Attachment B

**Planning Proposal – 47-51 Riley Street,
Woolloomooloo (as amended following public
exhibition)**

Figure 19 15. Proposed maximum building envelope as amended following public exhibition – 3D view from the north east

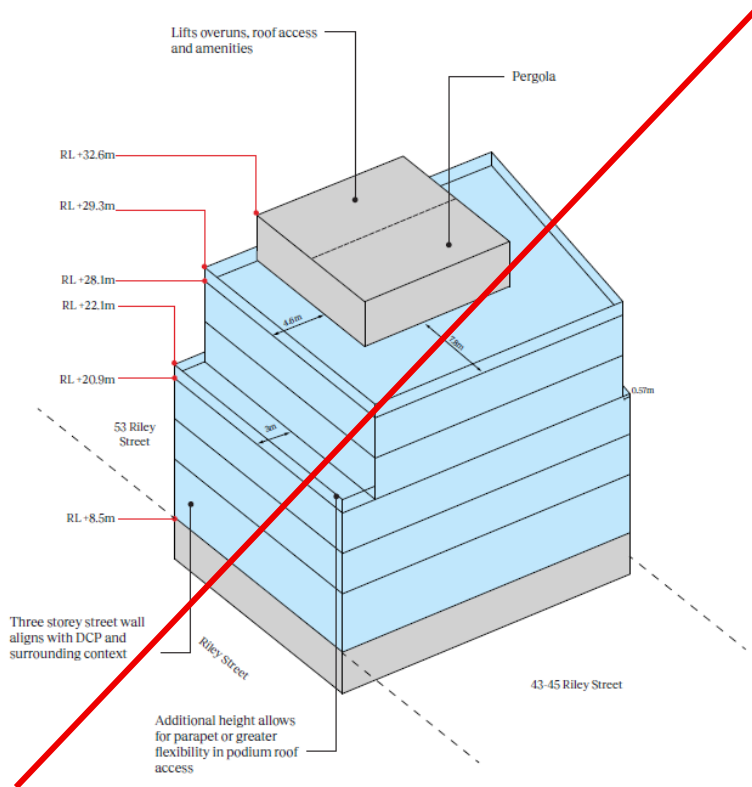
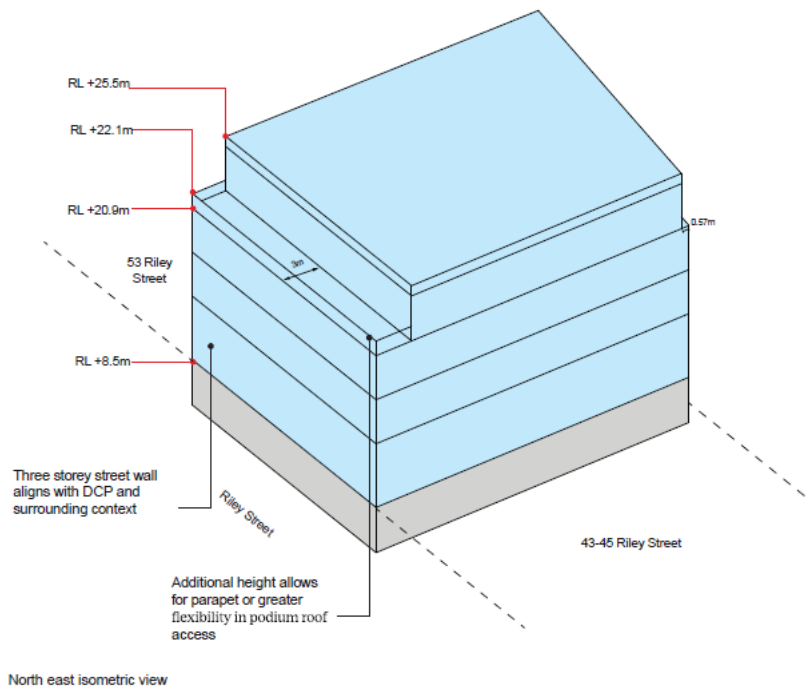
The proposed building envelope, as recommended to change post-exhibition, will allow a future building to respond to the context of the site. The proposal respects the scale of immediately adjoining properties through a podium, and with zero setbacks the building's edge will contribute to a cohesive streetscape form.

Figure 24 20. ~~Key local views from nearby buildings~~ View from apartment located on level 5 of Paramount Apartments building

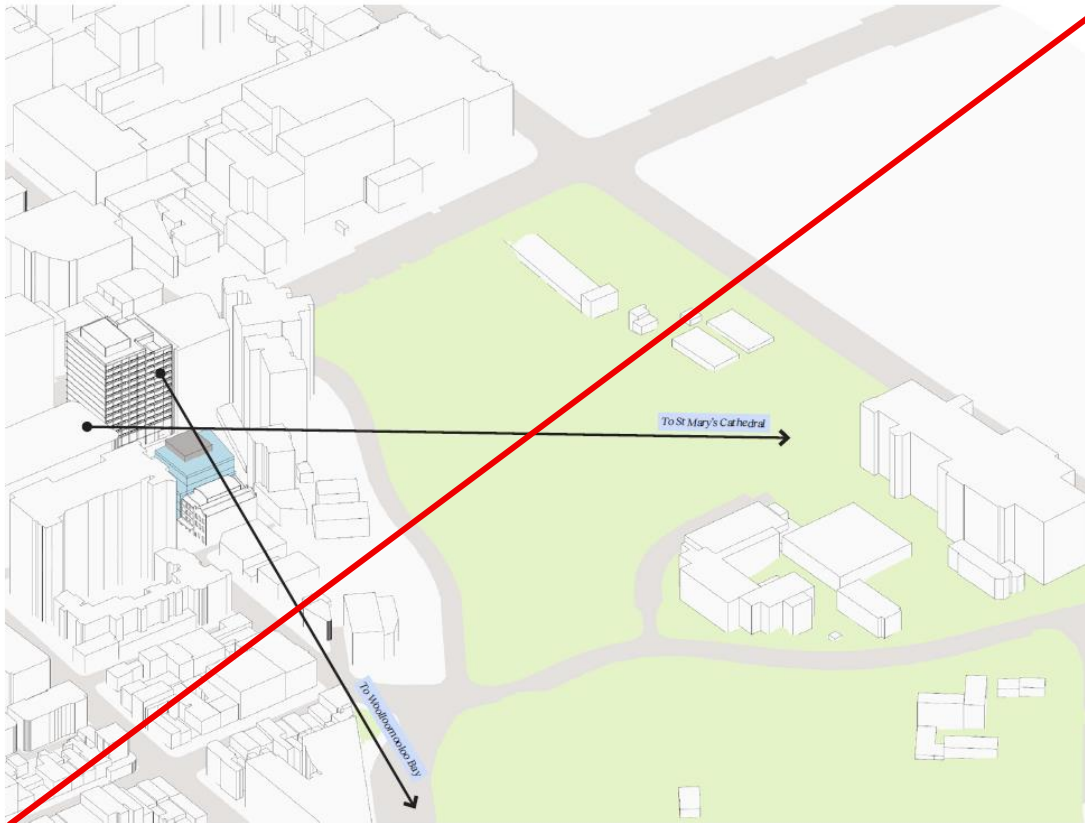
Figure 24 shows the view out from an apartment on Level 5 of the Paramount Apartment building.

These proposed amendments to the planning proposal would have the effect of reducing the impact on the views and outlook enjoyed by neighbouring residential properties. City staff have undertaken an independent view impact analysis to assess the impact of a future building with these reduced controls. This assessment is within the post-exhibition Council report.

Figure 25 23. Ground floor plan of indicative design showing retail use and commercial lobby fronting Riley Street

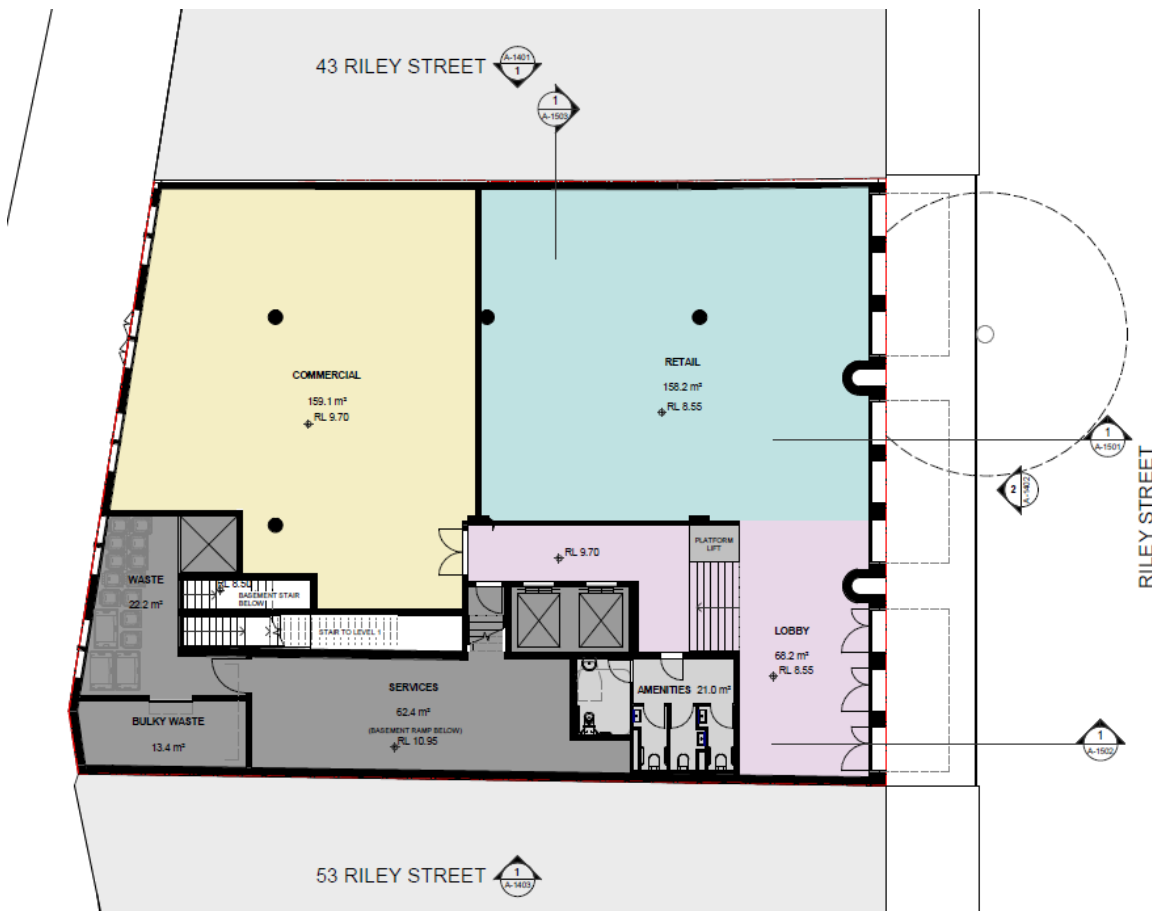
The planning proposal includes retail floor space at ground floor level fronting Riley Street, to contribute to the activation of the street front. The indicative reference scheme submitted as part of the planning proposal documentation shows a lobby for the building's commercial suites being accessed from the Riley Street frontage of the building. See Figure 25 23.

The site specific DCP (Attachment B) will contain provisions requiring a minimum of 158 square metres of retail floor space at ground floor level, with a minimum frontage to Riley Street of 11.5 metres. It will also require main pedestrian access to be from Riley Street and the commercial lobby to be visible from Riley Street. Combined, the retail use and commercial lobby for the building will make a positive contribution to the activation and vibrancy of Riley Street.

Figure 26 24. Indicative design of basement carpark

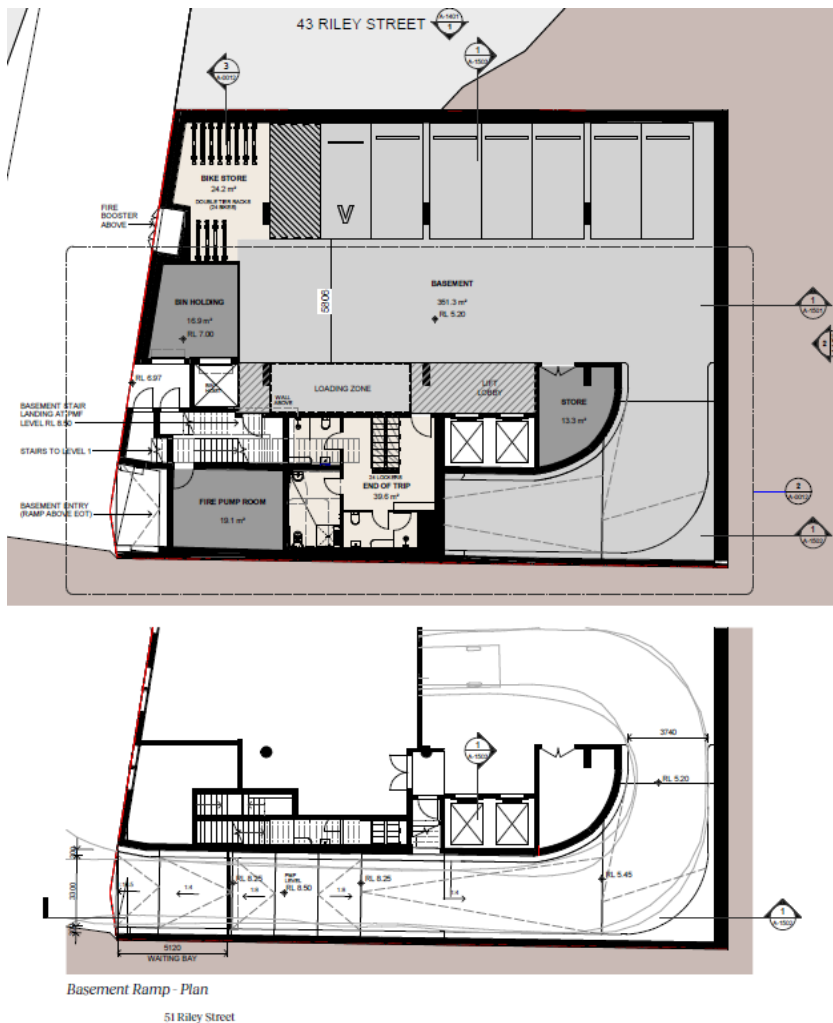
The indicative design submitted with the planning proposal proposes a basement carpark accessed from Busby Lane, but with the vehicular access point on the southern side of the Busby Lane frontage (rather than on the northern side as it is for the existing development on the site). The indicative design depicts a basement level accessed via a ramp with seven parking spaces (inclusive of one visitor space), a loading zone, a bike store for 24 bikes, end of journey facilities, a bin holding area and a fire pump room. See Figure 26 24.

With regard to vehicular entry and exit from the site, it appears that B99 vehicles appear not to be able to achieve clear entry and exit swept paths. Swept paths within the basement itself will also need to demonstrate how vehicles get into and out of the loading bay.

More detailed assessments will be needed as part of any future development application for the site, to ensure orderly waste servicing as well as safe vehicular movement into and out of the site and around the basement.
